STAFF REPORT FOR THE HISTORIC REVIEW BOARD

FILE NUMBER: DR-12-01

REQUEST: Rear addition/converted porch demolition and construction

Existing rear addition and deck

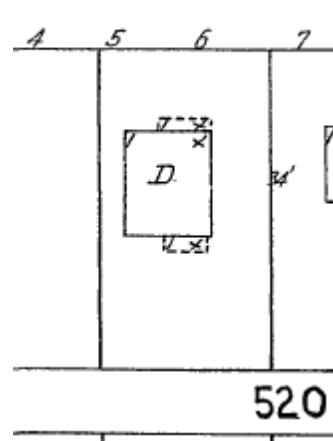
The demolition proposed is not for demolition of the entire structure. The demolition is only for the existing rear addition, a converted porch. Finding No. 13 addresses the demolition and that it is not proposed for a significant feature.

FINDING NO. 13: In this situation, the applicant is not requesting to demolish or destroy the structure, rather the proposal is to remove an existing converted porch/rear addition and construct a new addition. Per the Sanborn maps, the porch was likely on the residence since its construction. However, it is located to the rear, is not visible from the public right-of-way, and, particularly since it was subsequently enclosed, it does not contain significant architectural details. On the Sanborn maps, the porch appears to be smaller and the roof over the existing deck was likely added later. The rear addition does not appear to have significant architectural features, special character, or special historical or aesthetic interest or value. The City does not have additional information regarding the significance of this residence. It was not included in the 1984 Clackamas County Cultural Resource Inventory. Staff supports the demolition of the existing rear addition/converted porch.
